UNITED STATES PATENT AND TRADEMARK OFFICE

APPLICATION NO.	FILING DATE	FIRST NAMED INVENTOR	ATTORNEY DOCKET NO.	CONFIRMATION NO.	
10/619,891	07/15/2003	Vincent De Laforcade	NONY 3.0-004	7321	
530	7590 08/17/2006		EXAMINER		
LERNER, DAVID, LITTENBERG, KRUMHOLZ & MENTLIK 600 SOUTH AVENUE WEST			DOAN, ROBYN KIEU		
			ART UNIT	PAPER NUMBER	
WESTFIELI	O, NJ 07090		3732		
			DATE MAILED: 08/17/200	DATE MAILED: 08/17/2006

Application No.	Applicant(s)				
	10/619,891	DE LAFORCADE, VINCENT				
Office Action Summary	Examiner	Art Unit				
	Robyn Doan	3732				
The MAILING DATE of this communication appears on the cover sheet with the correspondence address Period for Reply						
A SHORTENED STATUTORY PERIOD FOR REPLY IS SET TO EXPIRE 3 MONTH(S) OR THIRTY (30) DAYS, WHICHEVER IS LONGER, FROM THE MAILING DATE OF THIS COMMUNICATION. - Extensions of time may be available under the provisions of 37 CFR 1.136(a). In no event, however, may a reply be timely filed after SIX (6) MONTHS from the mailing date of this communication. - If NO period for reply is specified above, the maximum statutory period will apply and will expire SIX (6) MONTHS from the mailing date of this communication. - Failure to

Affachment A

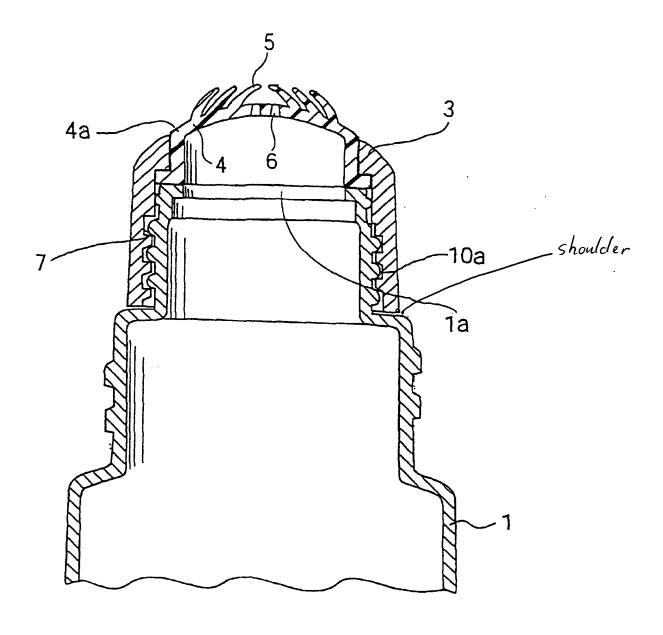
With regard to claims 48, 52 and 89, Ogino et al discloses a cosmetic receptacle (fig. 1) comprising a body (1) containing a cosmetic (col. 1, line 8), a neck (fig. 6 see attachment A) attached to the body, the neck comprising a first portion (see attachment A) having a first inside diameter (see fig. 6) and a first fixing means (10a) with thread, a second portion (see attachment A) located between the body and the first portion and having a second inside diameter (fig. 6) which is greater than the first diameter, the second portion further having a second fixing means (10) with thread, wherein the first and second threads inherently enabling screwing fastening in the same direction. In regard to claims 49, 50, Ogino et al shows the neck having a shoulder (see attachment B) with a plane annular surface extending outside the neck, the shoulder being perpendicular to the neck (see attachment B). In regard to claims 58 and 63, 77, Ogino et al discloses at least one accessory (3) having an applicator (4) configured for removably fixing onto the neck by fastening only on the fixing means. In regard to claims 64 and 69, Ogino et al shows the applicator having teeth (5, it is noted that filaments 5 are considered as teeth) and the applicator also having a row of teeth (fig. 2) which includes a pair of end teeth, the end teeth having no dispenser orifices. In regard to claim 76, Ogino et al shows the applicator being made by molding (col. 7, lines 62-67). In regard to claims 79, 80, 81-84 and 91-95, Ogino et al discloses at least two accessories (2, 3), a first one including a cap (2) and a second one including an applicator (3) and wherein the two accessories each incorporating with the first and

second portions of the neck. Ogino et al also shows the receptacle being filled with cosmetic (col. 1, line 8).
